ADDENDUM NO. A

Date: January 8, 2026

Owner: Food Bank of Northern Nevada
550 Italy Drive
McCarran, Nevada 89434

Addendum 'A' consists of thirteen (13) items, thirty five (35) answered questions, and four (4) attachments

a2.1

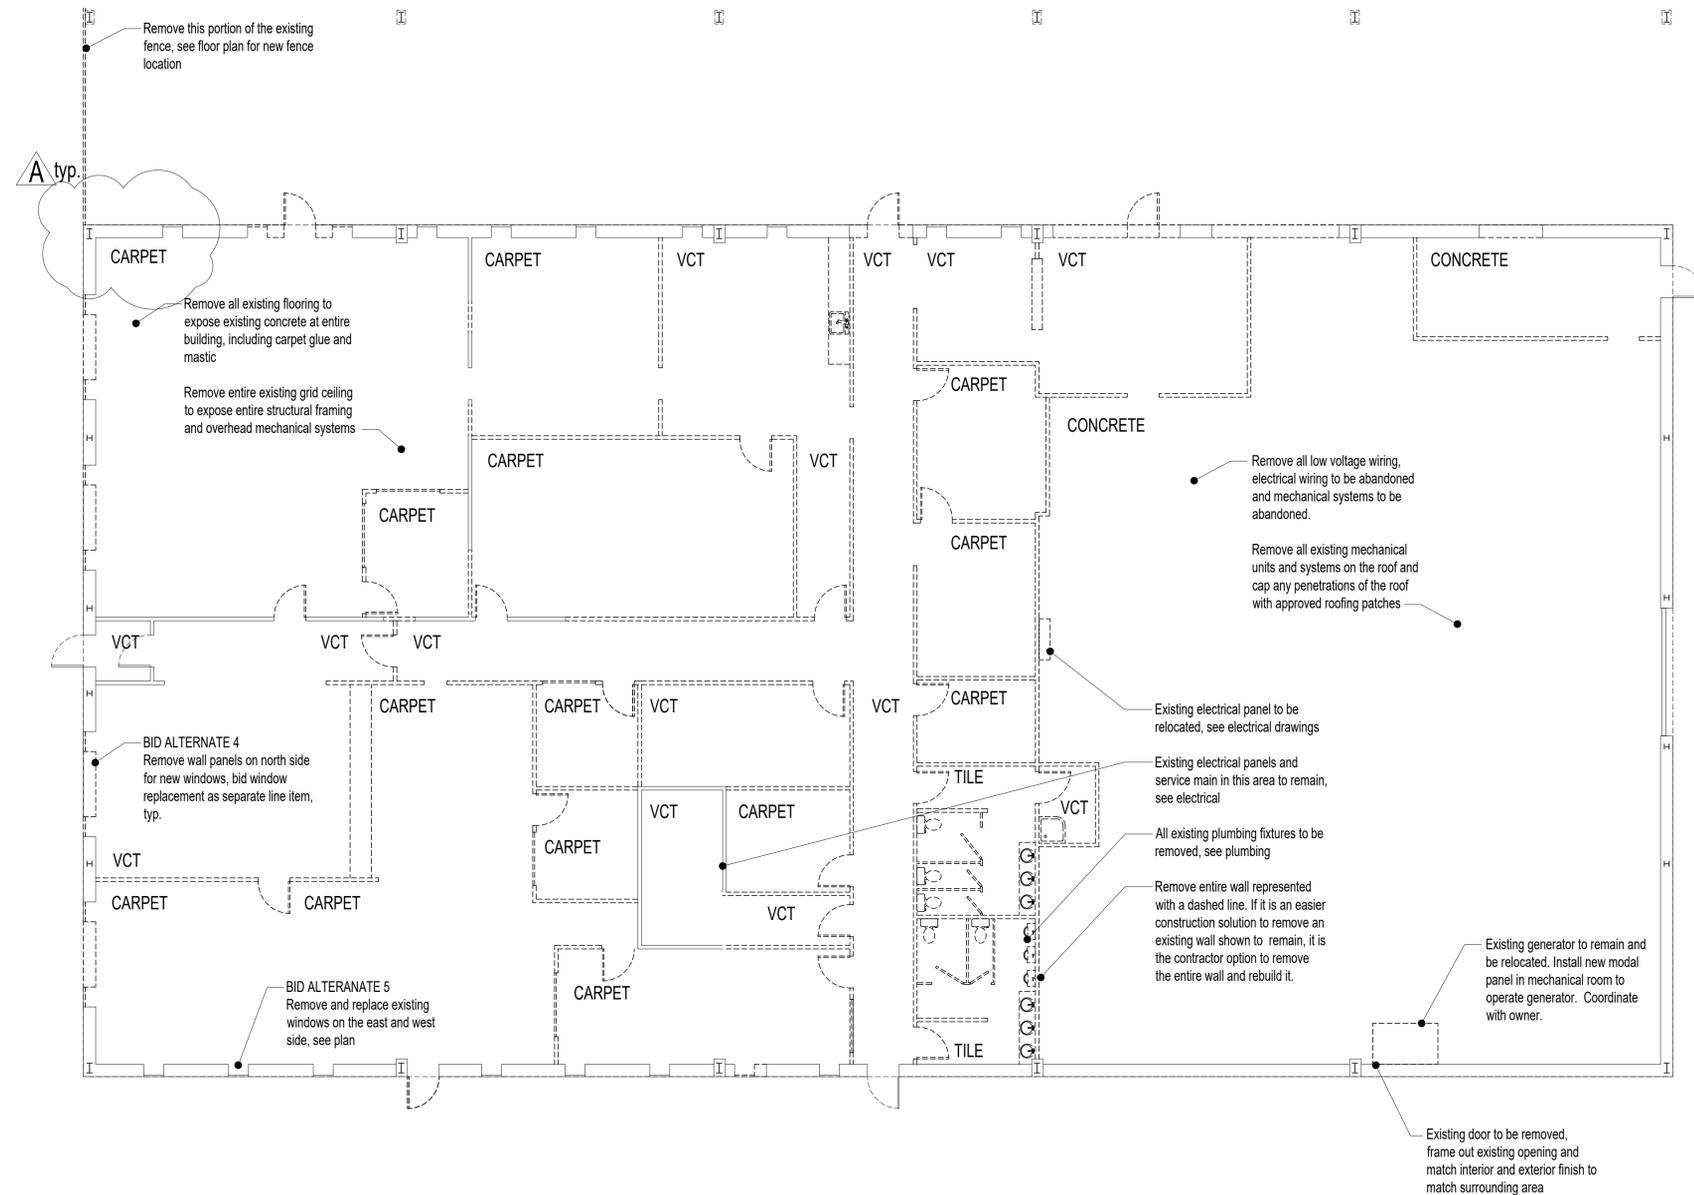
Sheet a2.1 has been revised to show the existing flooring material in each existing room.

Explanation: It was requested to indicate on the plans to inform flooring contractors of the material that will need to be removed.

TITLE SHEET

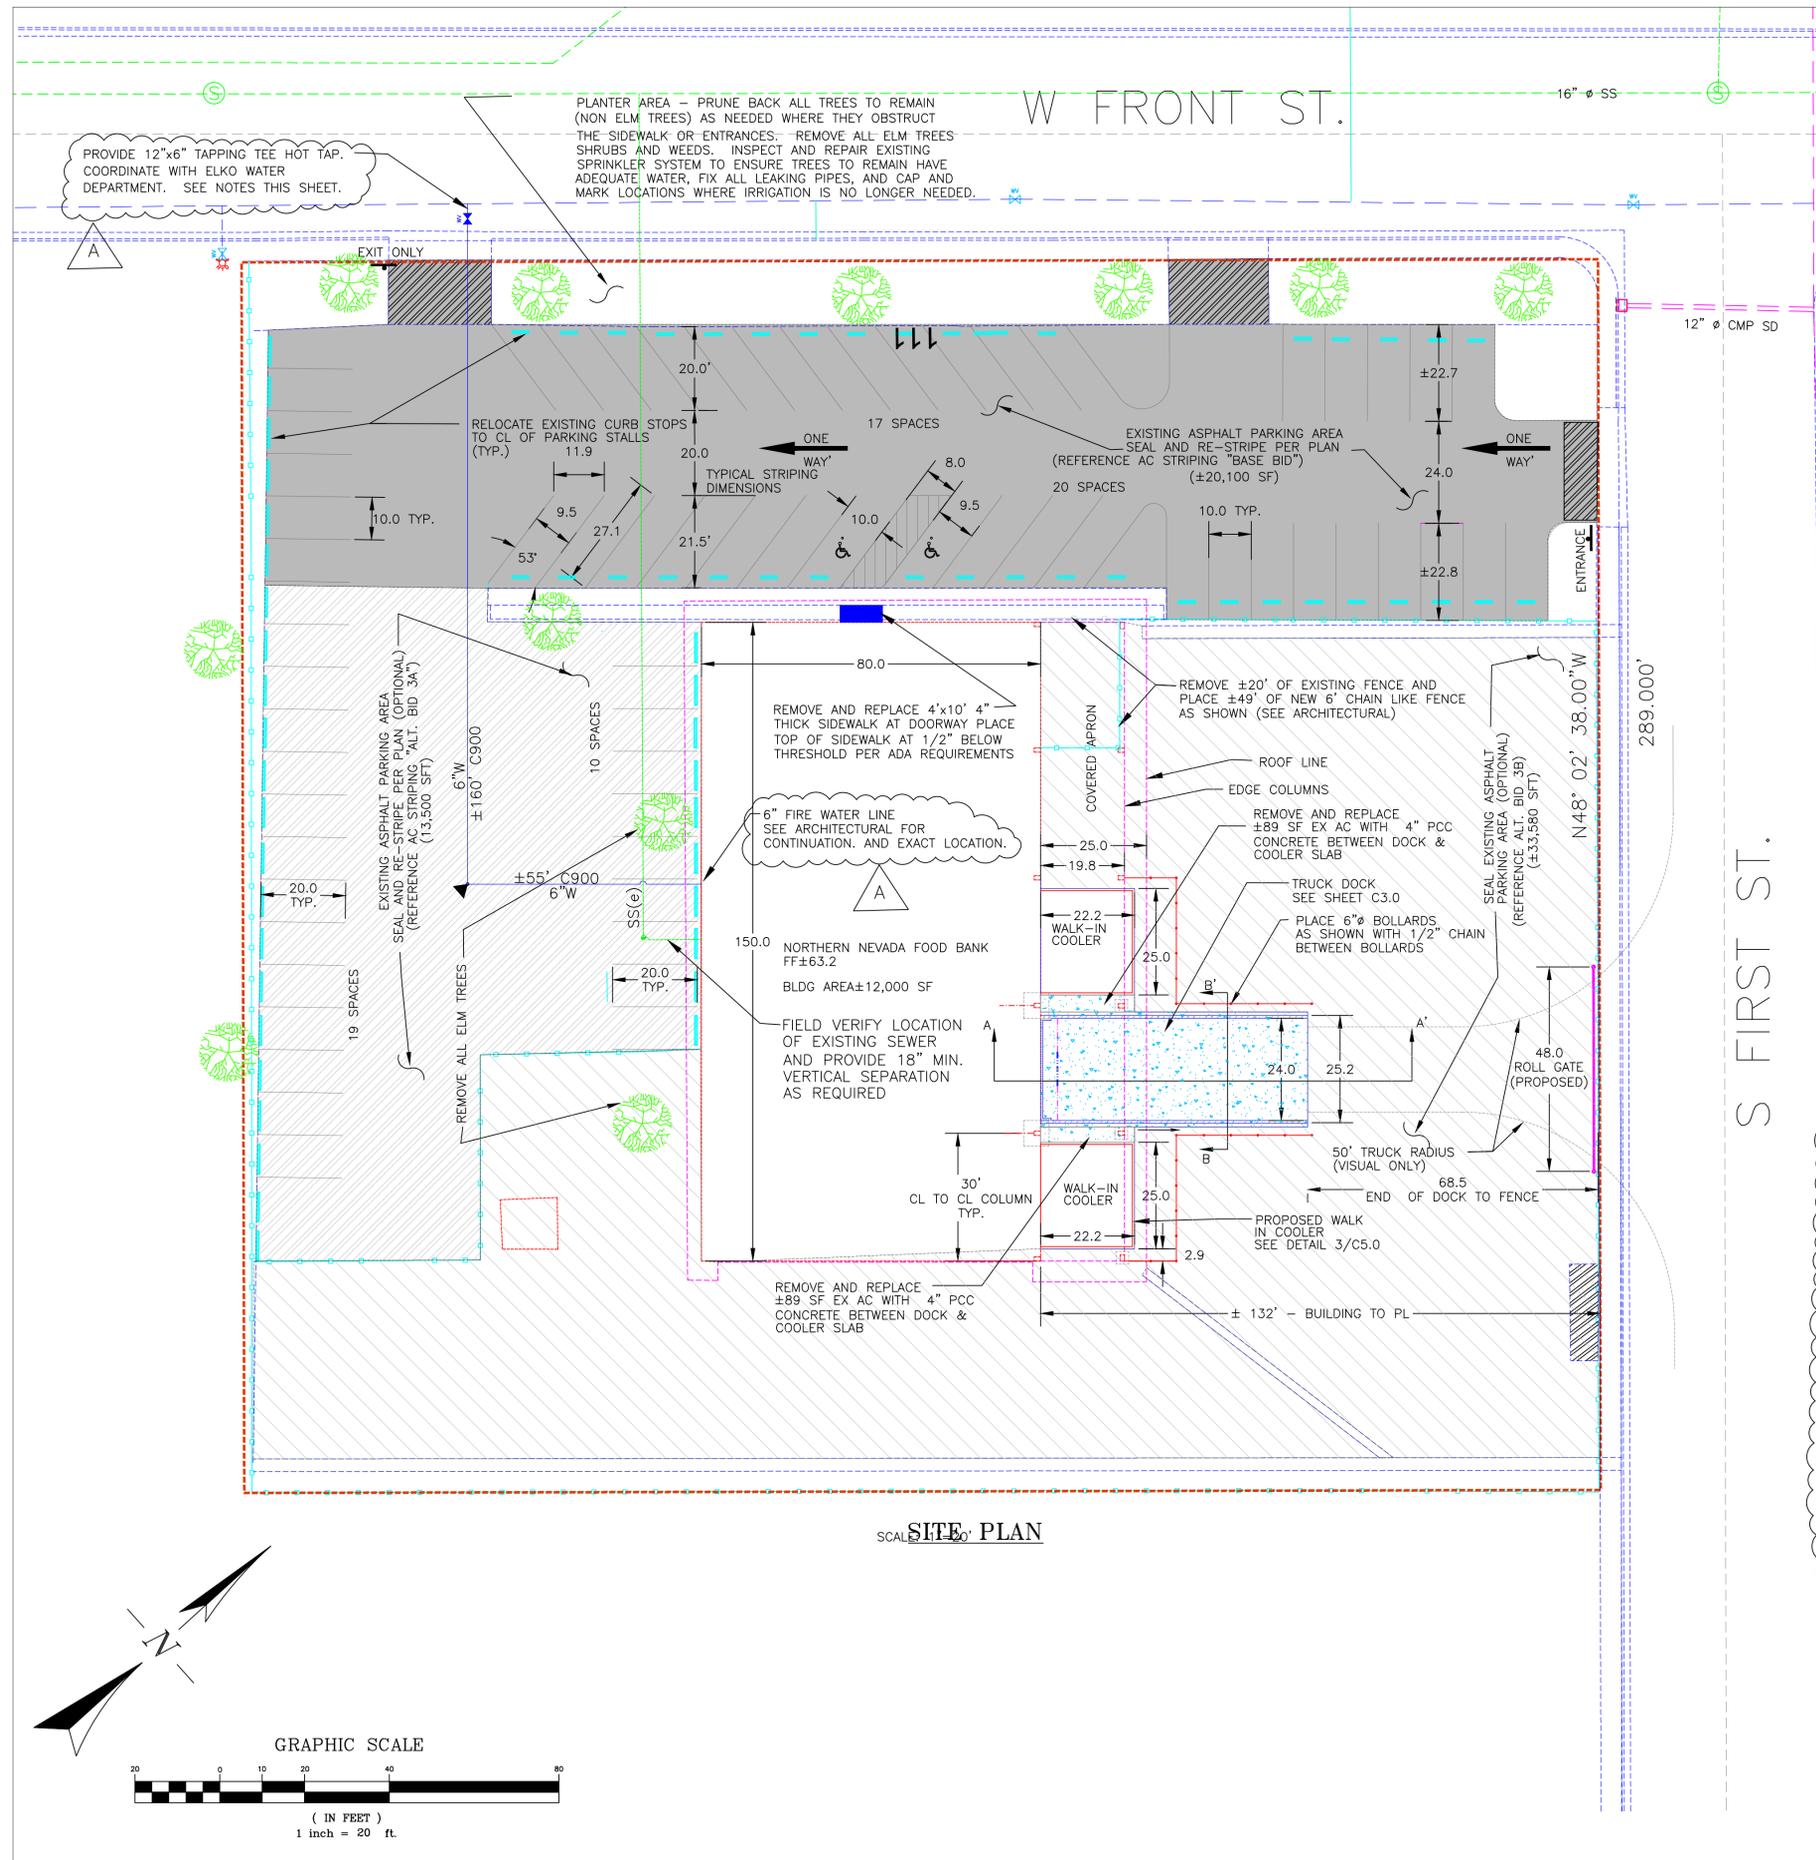
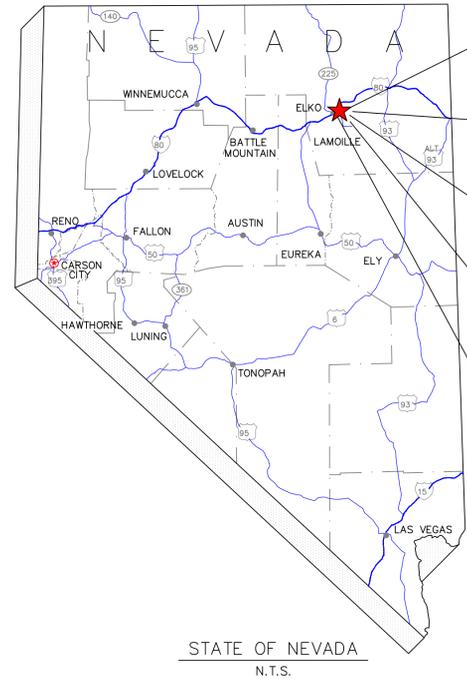
Sheets c1.0 and c2.0 have been revised to show detailed call out for the slurry seal at the parking areas required for base bid and also bid alternates.

SITE PLAN
SCALE 1/4" = 1'-0"

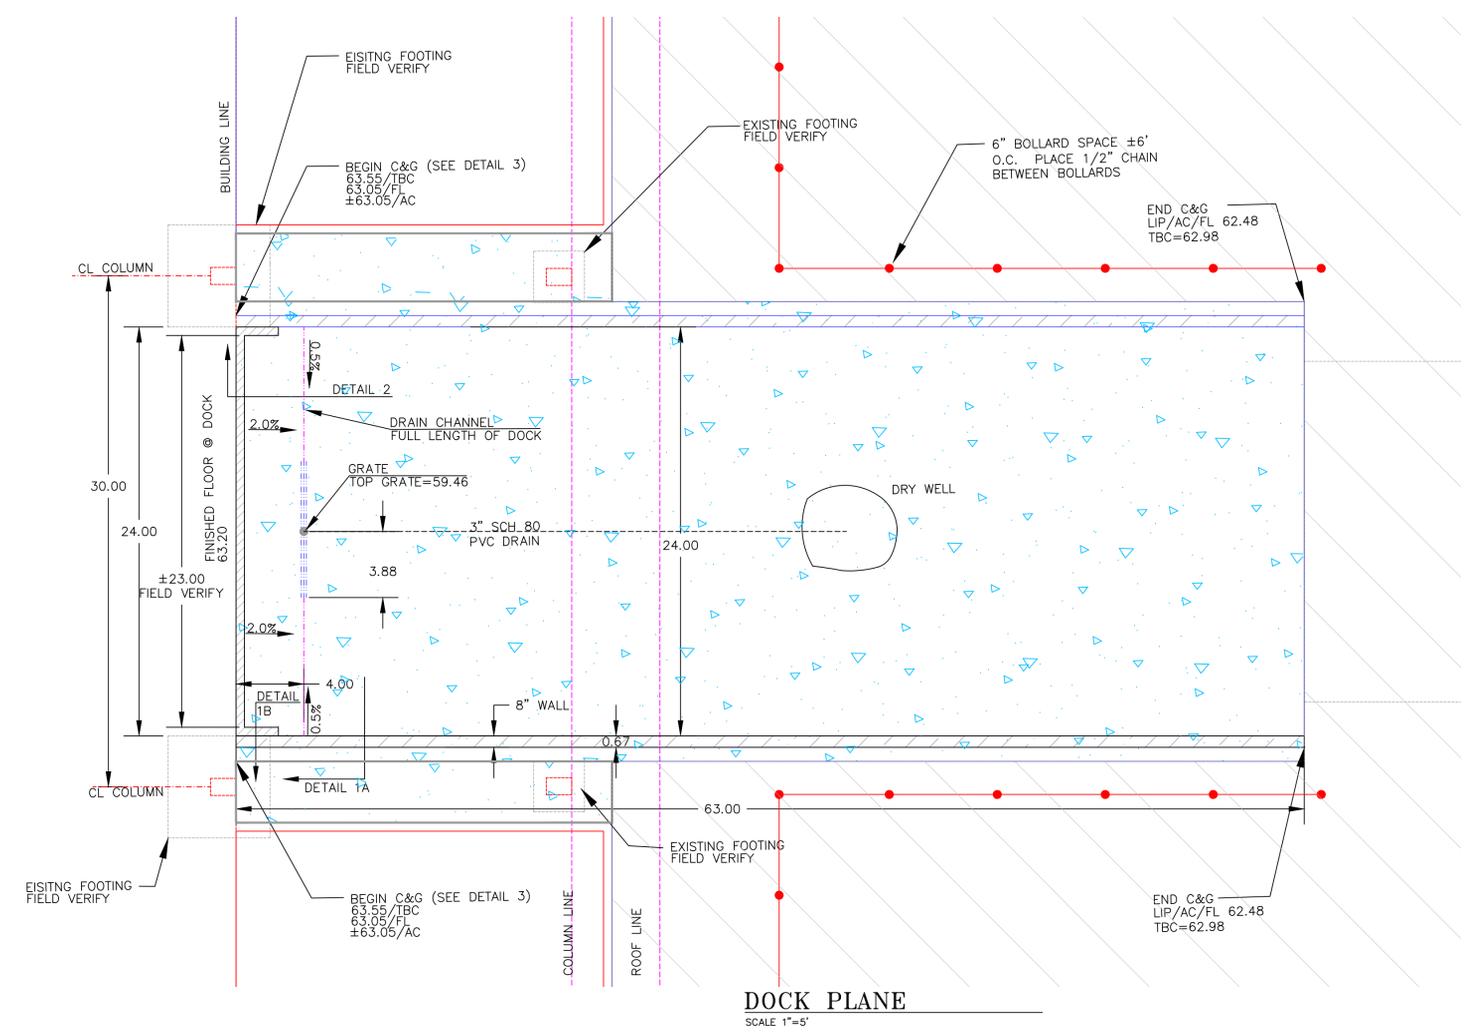
Sheet c2.0 has been revised to show the fire water line for bid alternate 6. Asphalt will be required to be patched, replace asphalt as required per City of Elko standard details.

- FIRE WATER LINE TO MATCH FIRE SPRINKLER PLANS. FOR BID PURPOSES ASSUME 6" WATER LINE AND 12"x6" TAPPING TEE. WATER LINE TO BE DR 18 CLASS 350 C900 PVC PIPE, UNLESS OTHERWISE SHOWN. ALL CONSTRUCTION TO BE AWWA C-600 OR AWWA C-605 COMPLIANT AS APPROPRIATE. MINIMUM COVER OVER THE WATER AND SEWER MAINS SHALL BE 42".

DOCK PLANE
SCALE 1"=5'

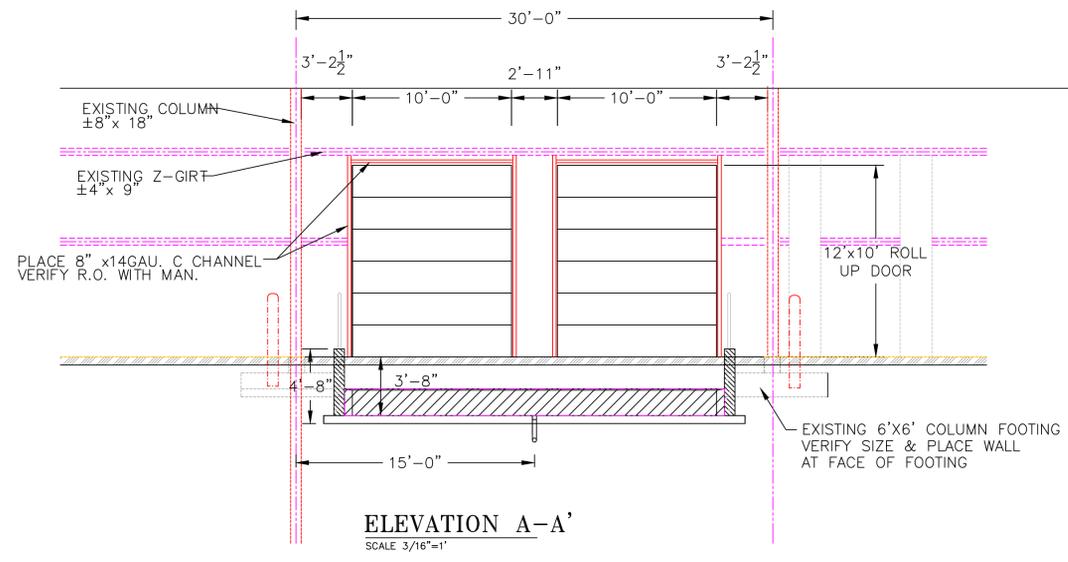
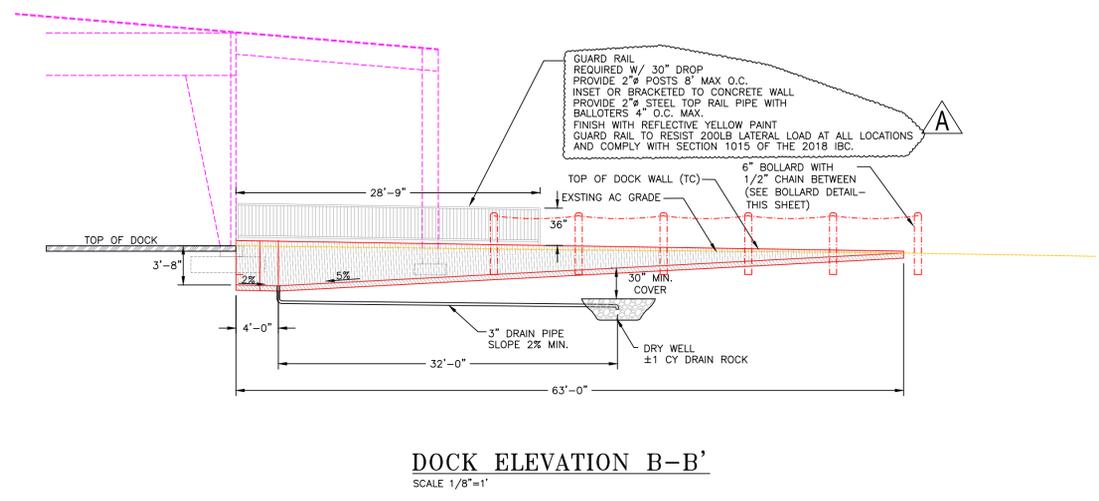
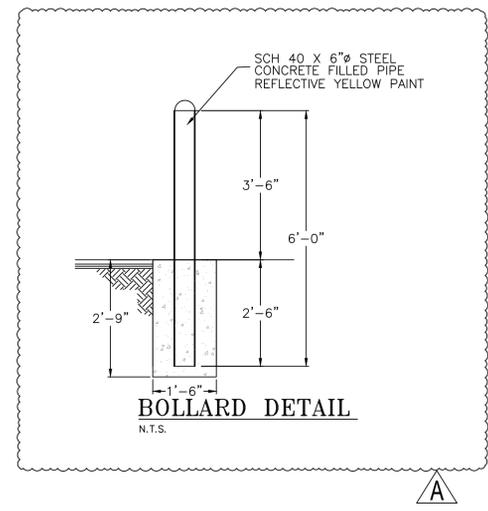
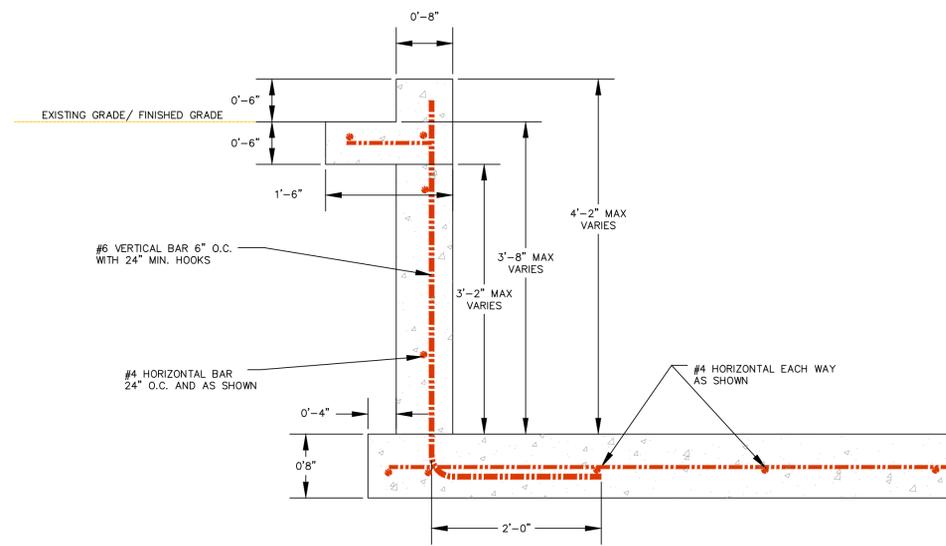
Sheet c3.0 has been revised to call out a specific guard rail for the dock

Explanation: the new guard rail must comply with IBC 1015. Bollards to be installed to protect all structural members near the dock and the cooler and freezer.
